Motorcycle/ATV Division

TL/SV/DL No. 61

SAFETY AND EMISSIONS RECALL CAMPAIGN 2A53 2014-2015 DL1000A/AA Wiring Harness

Affected Models: 2014-2015 DL1000A/AA

Inspection procedure flow chart:

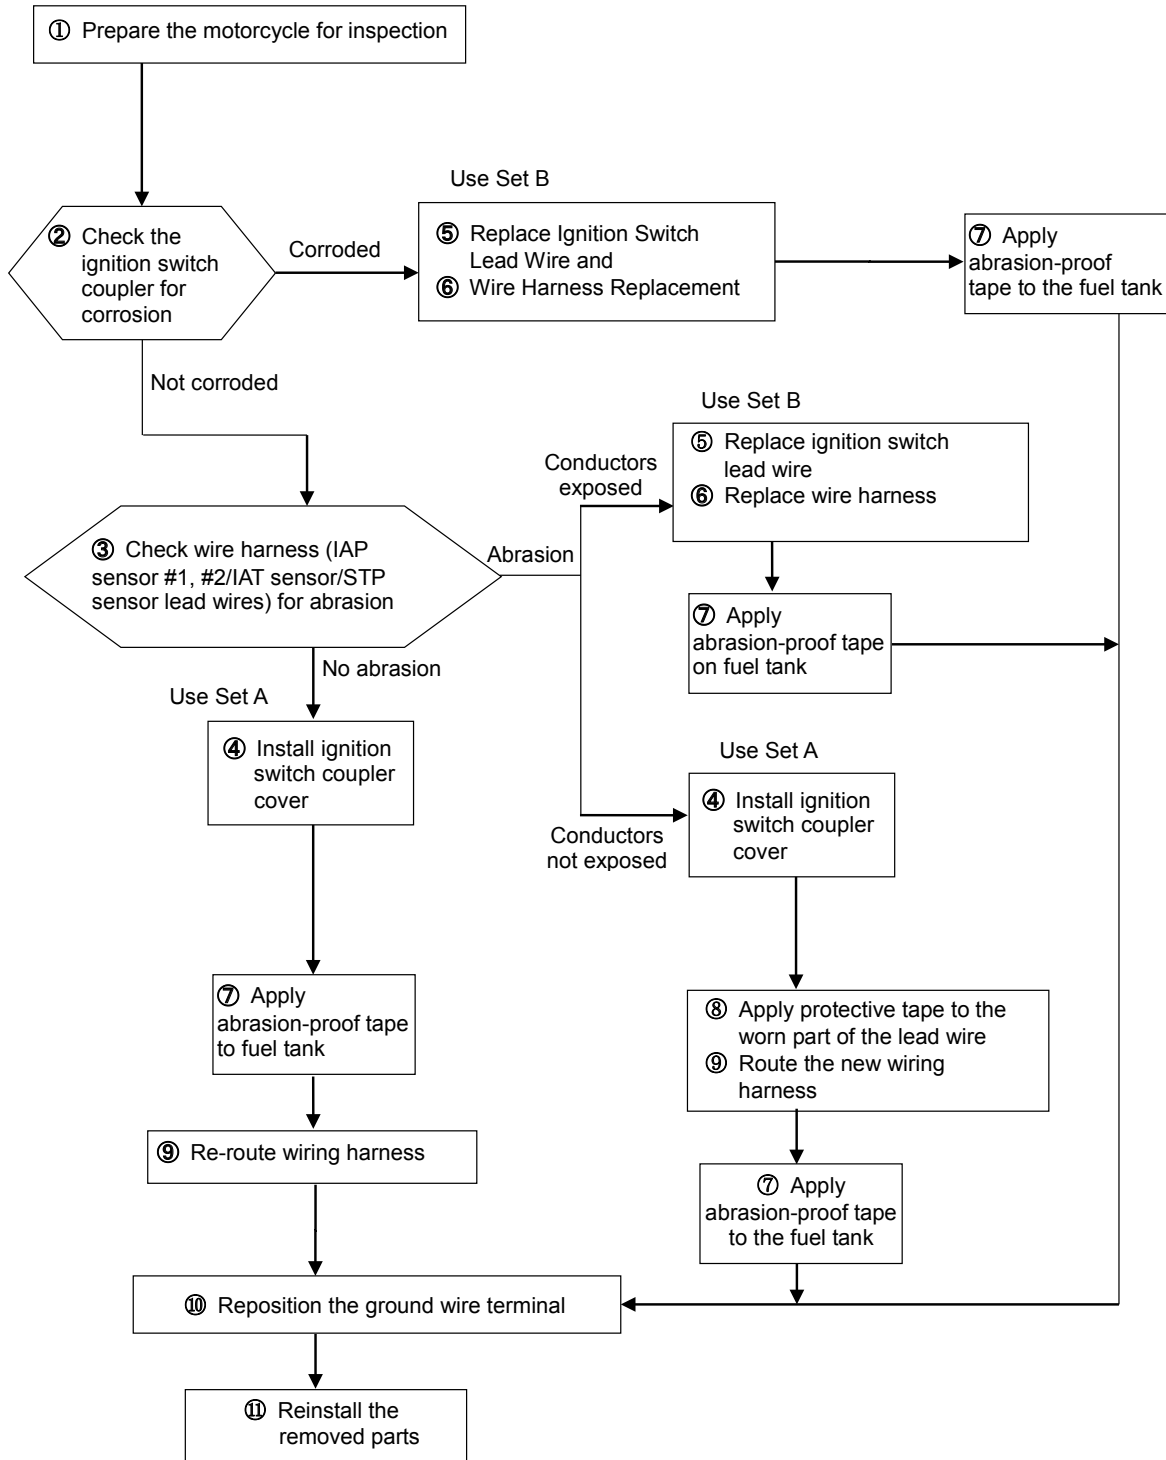
The wiring harness may contact the bottom of the fuel tank due to improper routing. Vibration from riding can cause the wiring insulation to wear off, allowing the bare wire to contact the fuel tank, creating a short circuit. As a result, the engine may stall while riding, increasing the risk of a crash. Emissions control performance could also be affected.

If the ignition switch connector is splashed with a corrosive liquid such as salt water, the terminals can corrode. If the corrosion progresses, the ignition lead wire and wire harness terminals of the connector can be connected, completing the power circuit independent of the ignition switch. Under this condition, the engine cannot be stopped by turning off the ignition key. The corrosion can also lead to a loss of electrical power. If electrical power is lost, the engine may stall and it may not be possible to restart it, increasing the risk of a crash.

The battery ground connection may develop poor conductivity due to corrosion or a weak connection to the painted surface of the crankcase to which it is attached. This could cause the engine to stall and prevent it from being restarted, increasing the risk of a crash.

Your dealership will inspect the wiring harness and, if necessary, the harness will be rerouted and/or repaired.

Your dealership will install a cover on the ignition switch connector, and if corrosion is found on the terminals, replace the ignition lead wire and wire harness.

Your dealership will relocate the battery ground connection to an unpainted surface and will replace the ground wire protector with a high-heat-resistant tube to protect the wire from the exhaust pipe that is near the new location.
